**Re: 120 Constitution Blvd  
Site Plan Peer Review**

BETA Group, Inc. has reviewed the 3<sup>rd</sup> set of revised documents for the project located at 120 Constitution Blvd. in Franklin, Massachusetts. This letter is provided to outline findings, comments, and recommendations.

- Plans (10 sheets) entitled: **Site Plan for Parking Lot Expansion** dated August 20, 2021, revised April 06, 2022, prepared by Howard Stein Hudson of Chelmsford, MA.
- Supplemental Data Report entitled: **Proposed Parking Lot Expansion** dated September 2021, revise April 2022, prepared by Howard Stein Hudson, Chelmsford, MA.
- **Response to Comments** memorandum from Kristen LaBrie-Howard Stein Hudson to Franklin Planning Board, dated April 06, 2022

# 120 Constitution Blvd

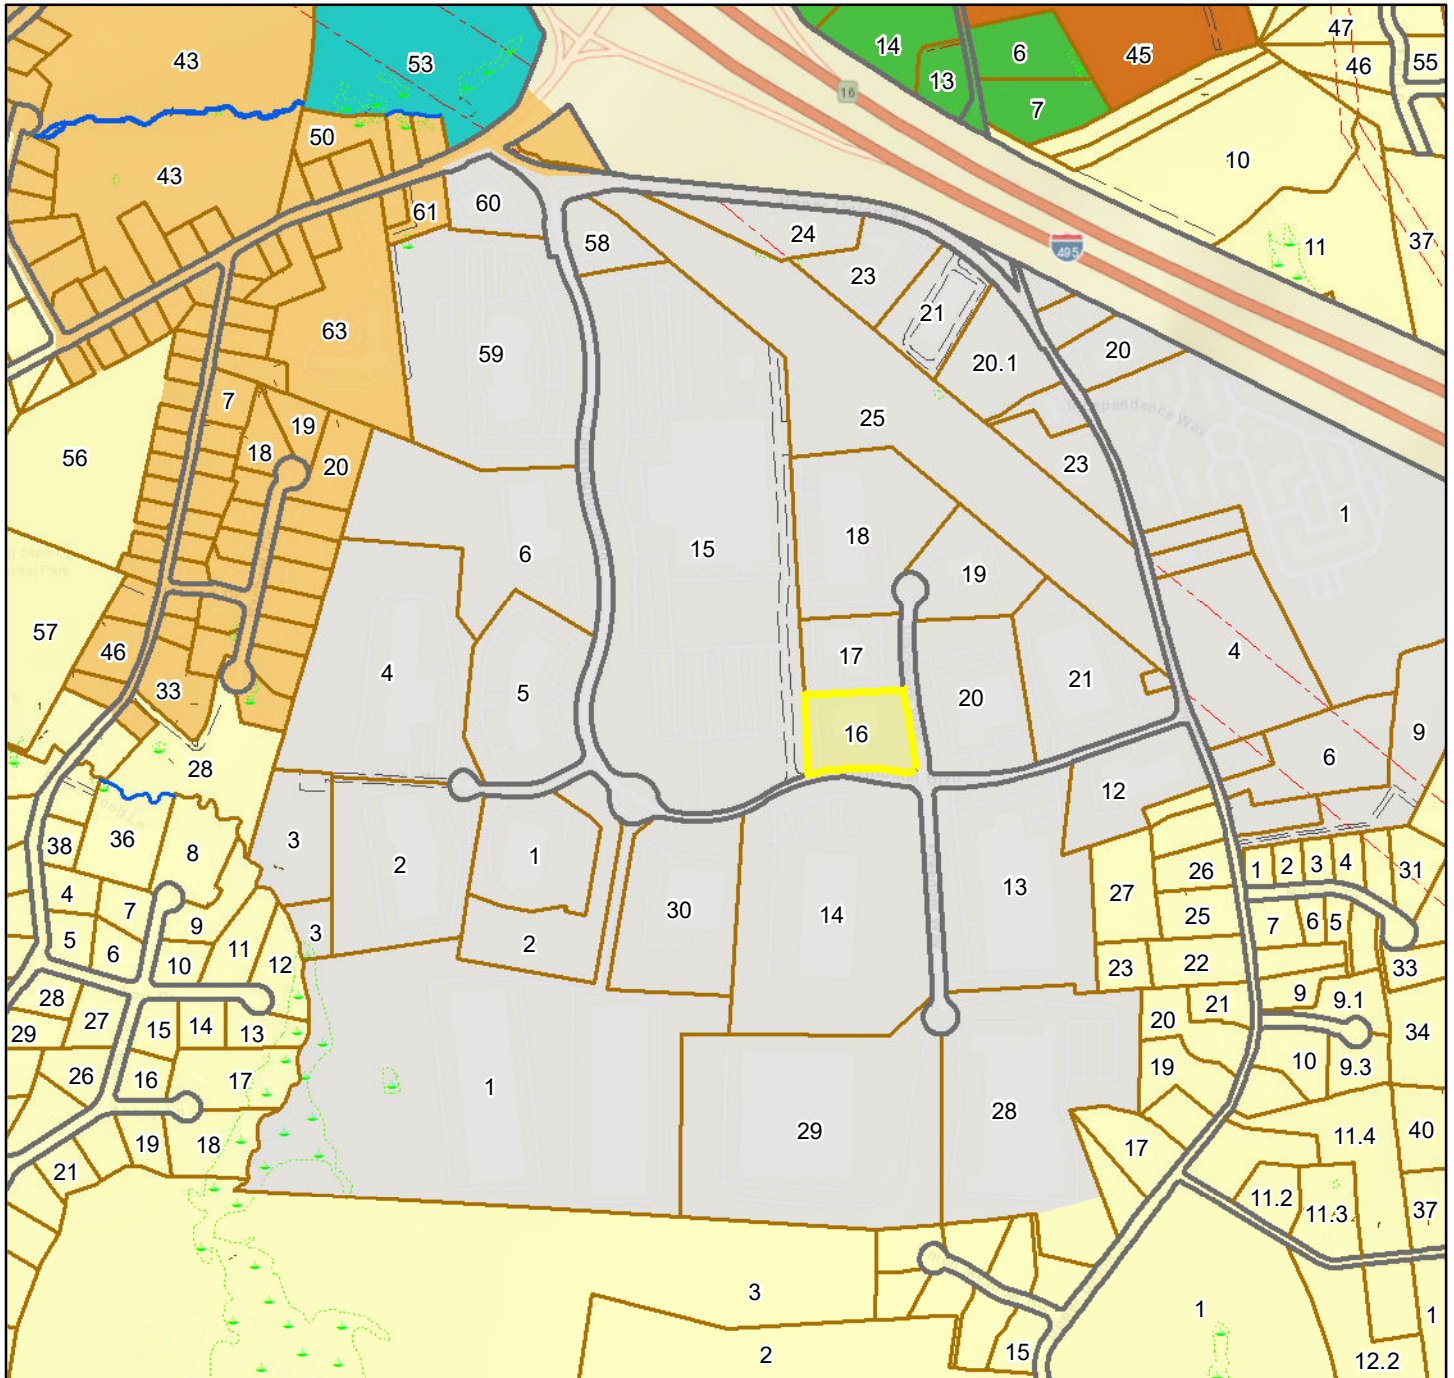
- SP1. Indicate abutting land uses and zoning data on the locus or vicinity map (§185-31.1.C(3)(d)).

**BETA: There are multiple uses allowed within the Industrial Zone. It is BETA's opinion that the use description should be more specific ( i.e. Manufacturing, office-warehouse, distribution...). It should also be shown on the plan rather than an attachment.**

*HSH: A vicinity map with zoning data has been attached to the end of this letter. This from the town's GIS system. The property lies within a planned industrial subdivision and is surrounded by such.*

**A vicinity map with zoning data has been attached to the end of this letter. This is from the town's GIS system. The property lies within a planned industrial subdivision, and is surrounded by such.**

**VEHICLE TRACKING PLAN**

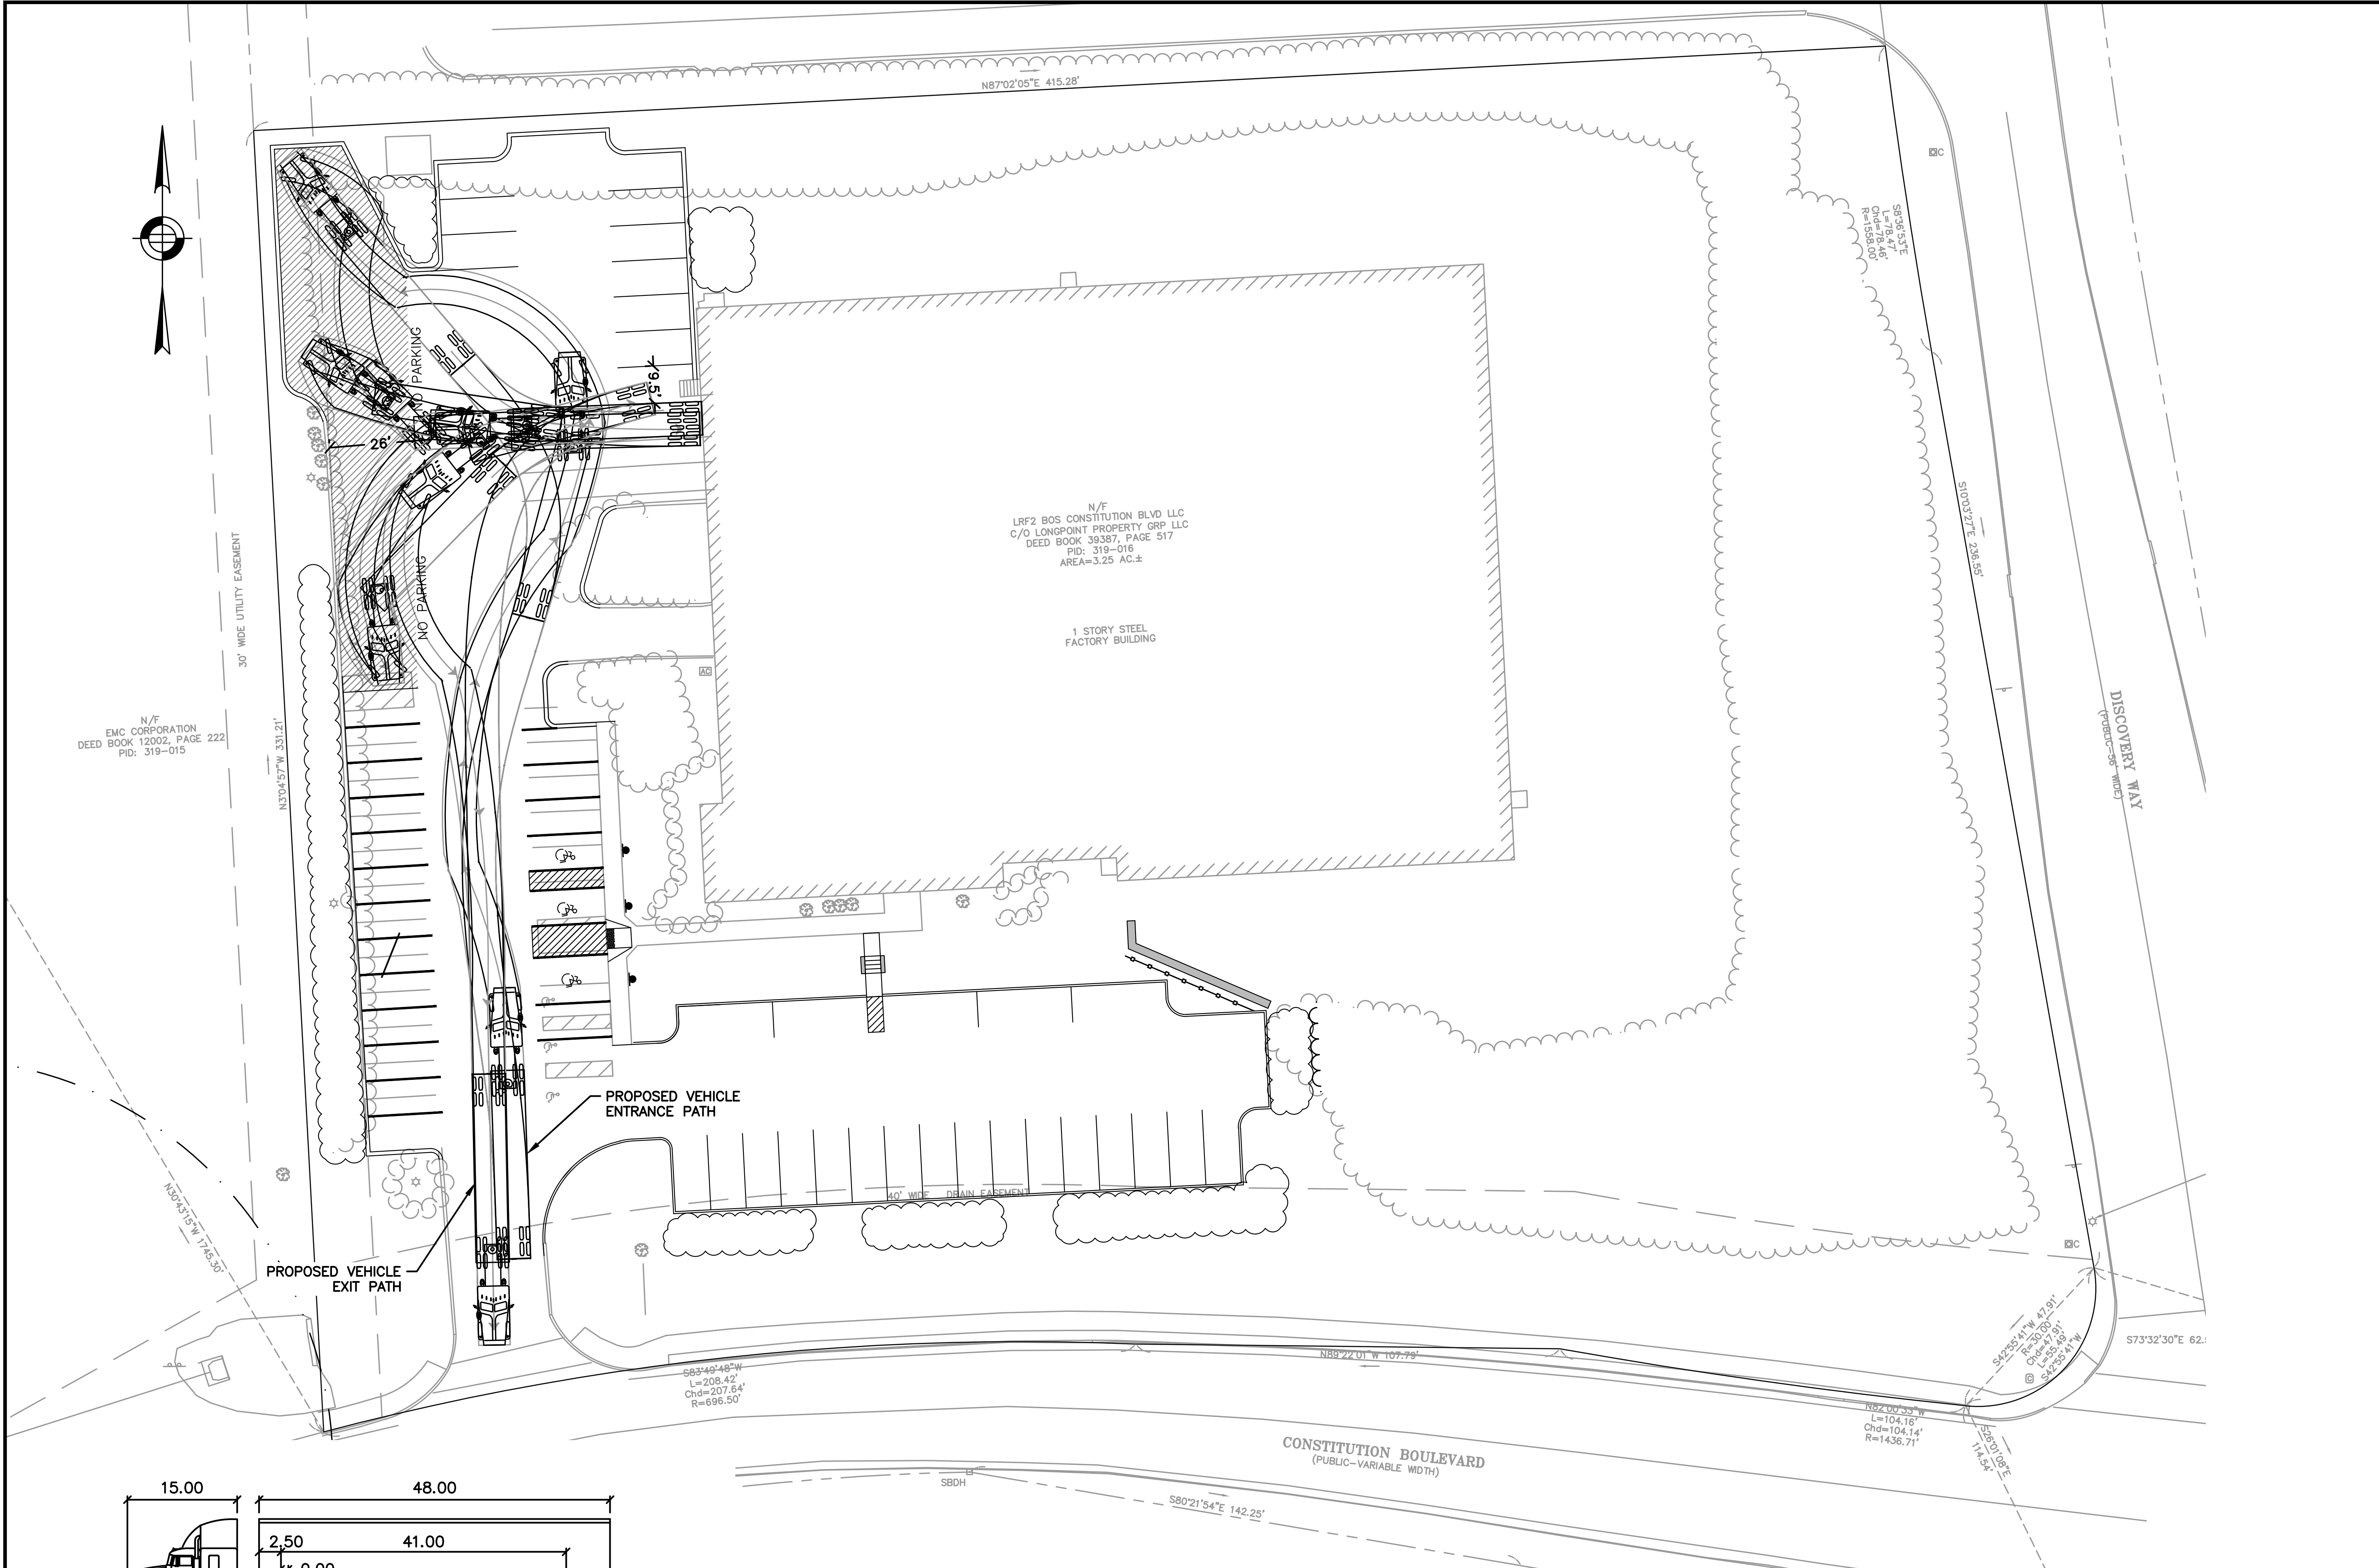
- P3. Graphically, show the largest anticipated delivery truck parked at the loading dock and how much space is outside the vehicle for access to and from the northerly parking area.

**BETA: As shown if a truck is parked at the loading dock access to the rear parking area will be through the lined "No Parking" area. With only the 48' trailer at the dock, there remains a 24' wide access aisle around the trailer outside the no parking zone. The board may wish to consider this since there are no spaces beyond the loading docks currently so it is not relevant currently.**

*HSH: HSH has verified that a WB-62 can adequately maneuver into the site and back up to the loading dock closest to the proposed parking. If a WB-62 is the size of the truck, during deliveries vehicles have approximately a 26' aisle in front of the truck to be able to access the remainder of the parking lot and exit. The parking to the north of the dock is approximately 9.5' away from the dock, and there is a staircase located between the dock and the parking area. A smaller delivery truck would create a larger driving access aisle while parked and require less room to maneuver into the loading dock. Please see "Vehicle Tracking Plan" attached here as an Appendix.*

**able to access the remainder of the parking lot and exit. The parking to the north of the dock is approximately 9.5' away from the dock, and there is a staircase located between the dock and the parking area. A smaller delivery truck would create a larger driving access aisle while parked and require less room to maneuver into the loading dock. Please see "Vehicle Tracking Plan" attached here as an Appendix.**
